I-73 South 2010 NEPA

INTERSTATE 73 SOUTH DILLON, HORRY, AND MARION COUNTIES, SOUTH CAROLINA

Final Environmental Impact Statement Re-evaluation

PROPOSED VE ALIGNMENT

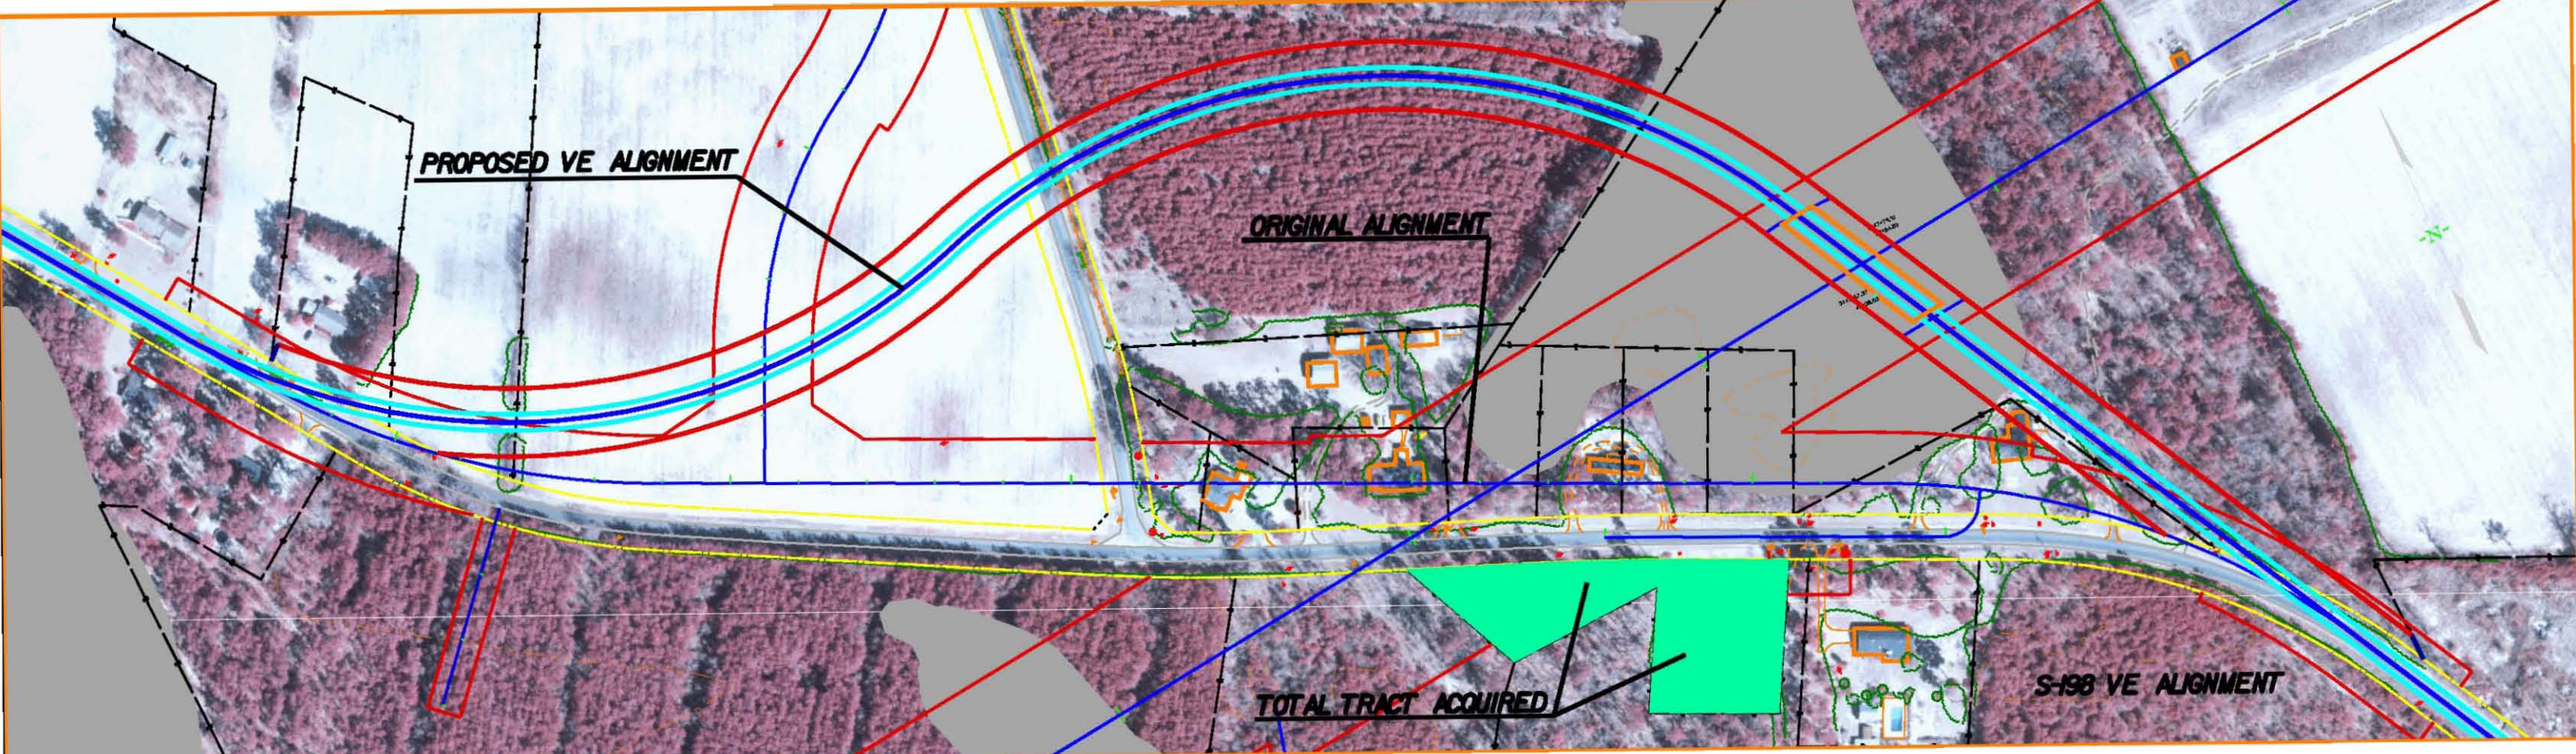
Reconfigure the bridge to reduce the heavy skew.

Pros	Cons
Cost savings of \$2.3 Million in bridge construction	Would require reopening the EIS document to assess the impacts
Eliminate need for run-around	Additional wetlands impact (.8 acres)
Skew improved	Some total-take tracts have already been acquired by SCDOT
Concrete girders require less maintenance than steel girders	
More predictable seismic behavior

PROPOSED VE ALIGNMENT

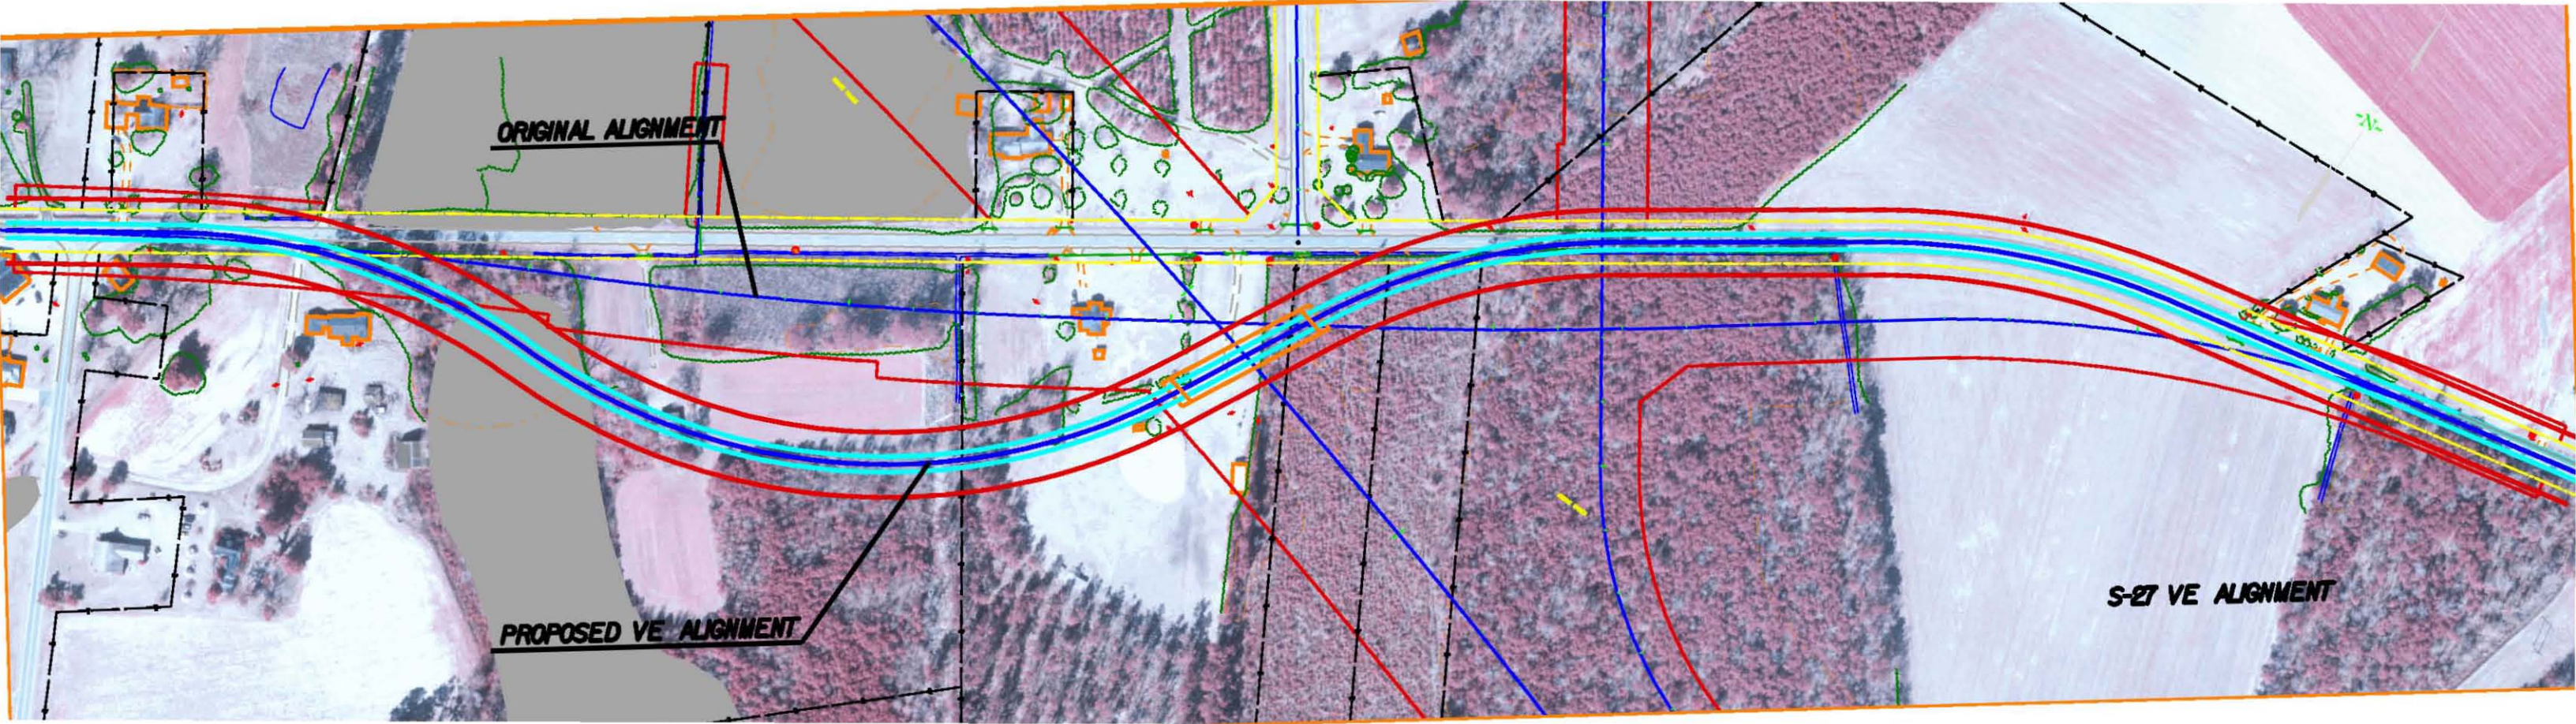
Reconfigure the bridge to reduce the heavy skew.

Pros	Cons
Cost savings of \$1.3 Million in bridge construction	Would require reopening the EIS document to assess the impacts
Skew improved	Additional wetlands impact (.3 acres)
Concrete girders require less maintenance than steel girders	Less desirable horizontal alignment for S27
More predictable seismic behavior	May cause additional displacement (structures on Tract 150)

ORIGINAL ALIGNMENT

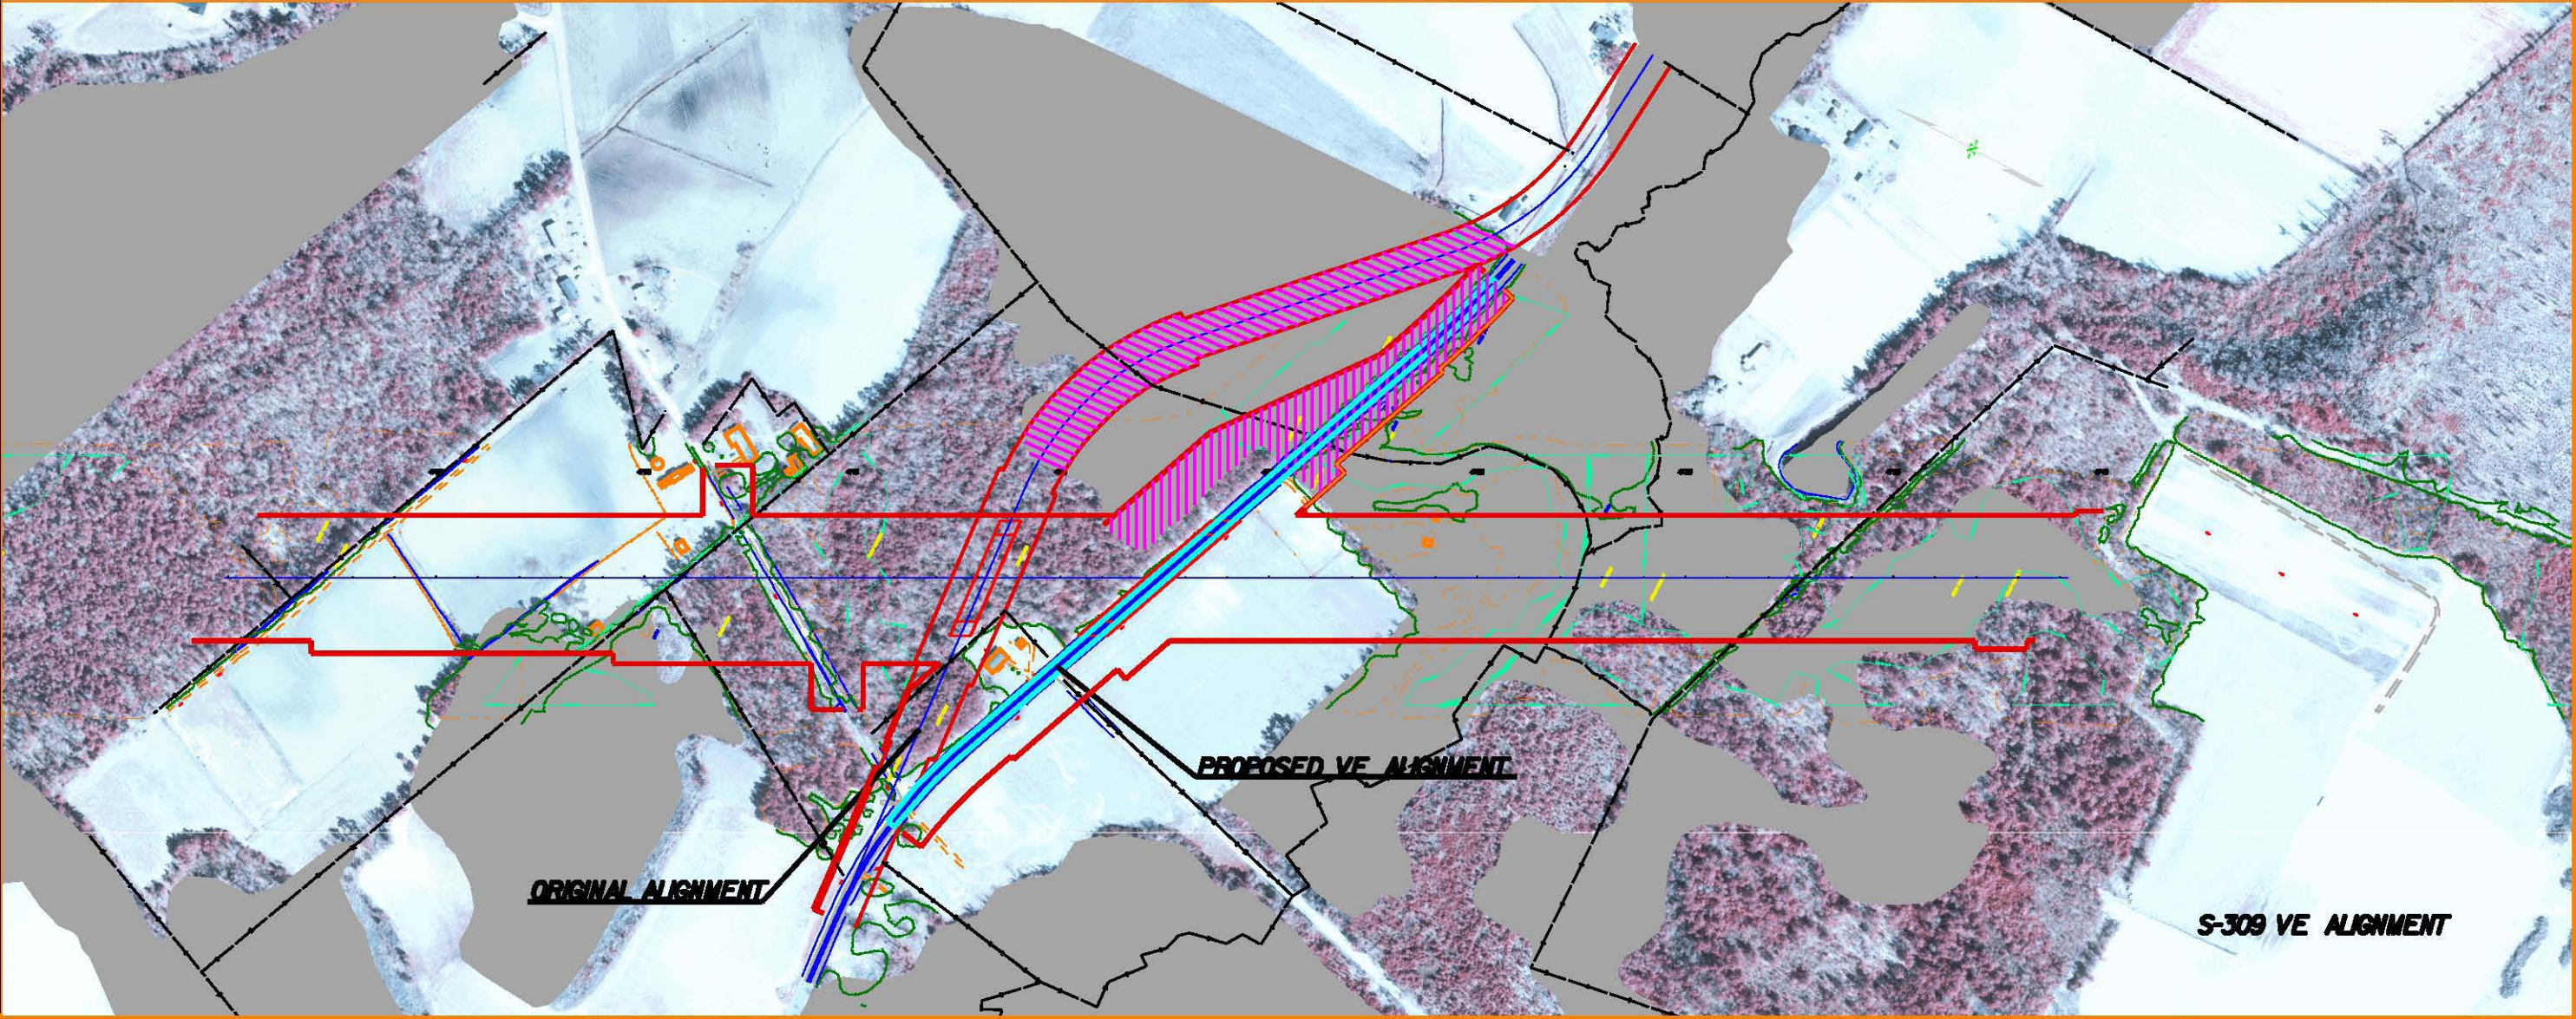
Reconfigure the bridge to reduce the heavy skew.

Pros	Cons
Cost savings of \$1.1 Million in bridge construction	Would require reopening the EIS document to assess the impacts
Skew improved	Additional wetlands impact of 3.2 acres
Concrete girders require less maintenance than steel girders	
More predictable seismic behavior

Justification for the S308 Interchange

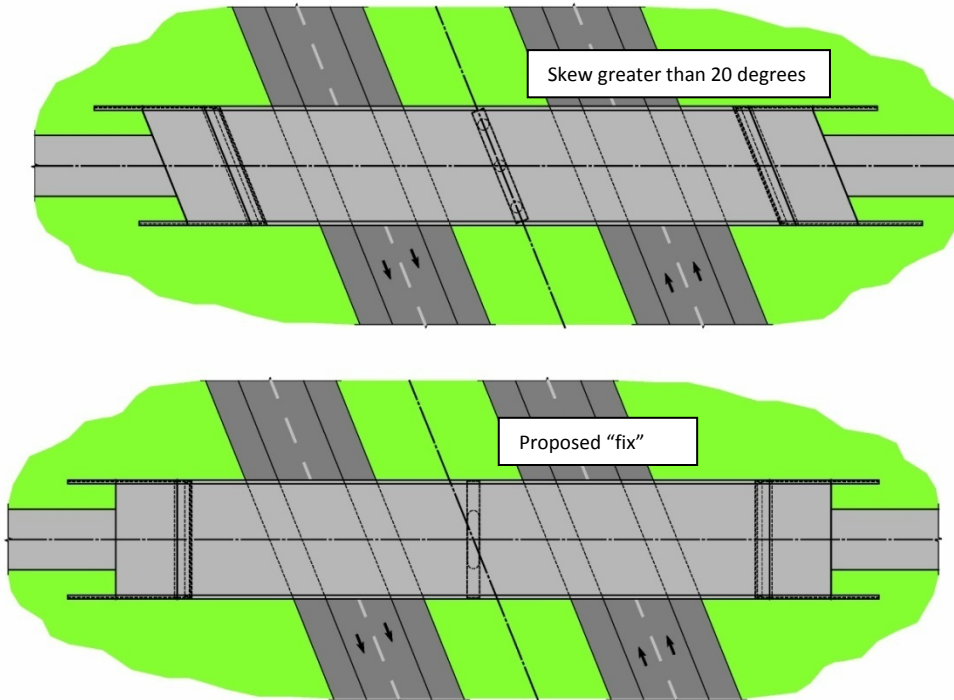
The VE Study asked the design team to provide justification for the S308 interchange and for the location chosen for that interchange. Here are their responses:

- Without the S308 interchange, there was no access between US 701 and US 76 interchange, a distance of over 25 miles.
- Other potential locations are at S23 (South Nichols Highway) or S99 (Lake Swamp Road). The communities at S23 and S99 did not want the interchange at those locations, fearing an interchange would alter the character of the community.
- There would be additional relocation impacts at either S23 or S99.
- Ketchup Town, located on S99, is considered to be a local landmark and would be impacted significantly by the interchange.
- Horry County requested the S308 location for the interchange to provide more direct access to the Cool Springs Industrial Park.

I-73/SC 22
Interchange:
Revise current
three-level,
multiple structure
interchange to a
T-type, trumpet
design.

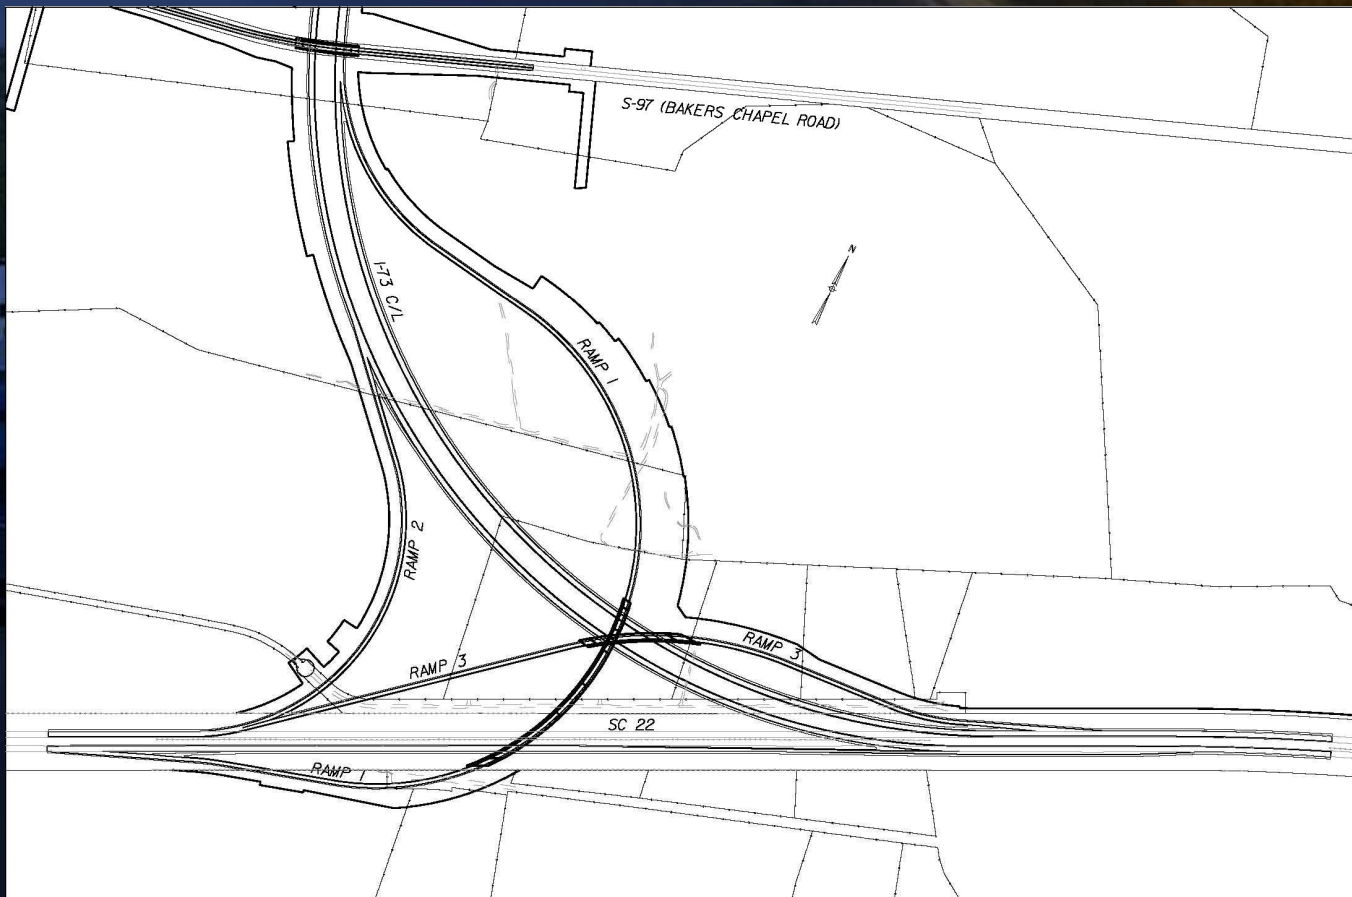
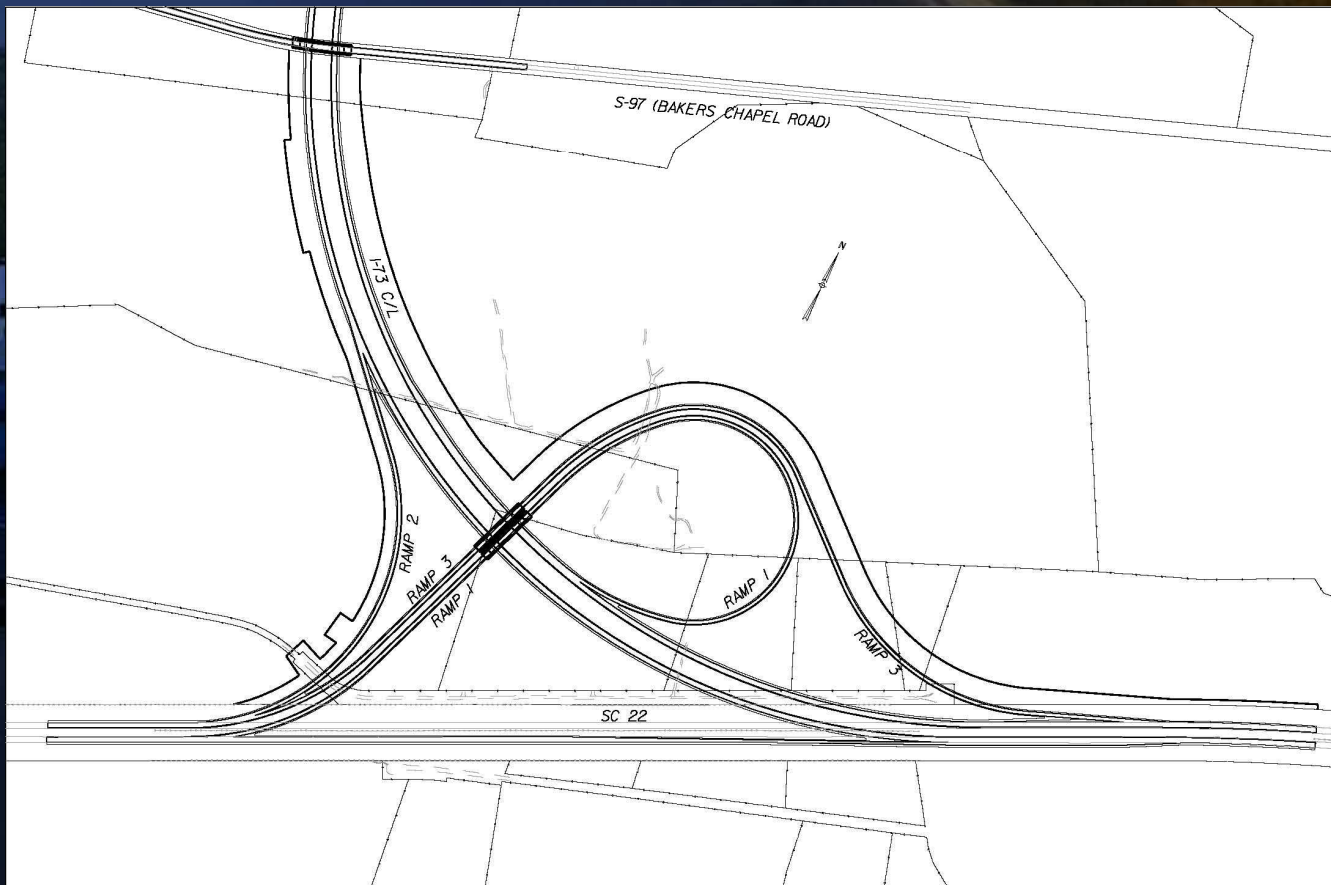
PROS	CONS
Reduce ramp fill heights and bridge requirements for a cost savings estimated at \$31.1 million	Safety issues with loop design
Lessen length of Bakers Chapel Road crossing bridge (end acceleration lane prior to crossing under the Bakers Chapel Road bridge)	Two of the four ramps will have reduced (60-40-60 mph) design speeds – directional ramps are all 55 mph
No conflict with hurricane evacuation	May require reopening the EIS to assess impacts
Handle estimated volumes at design year (with projected SELL project volumes)
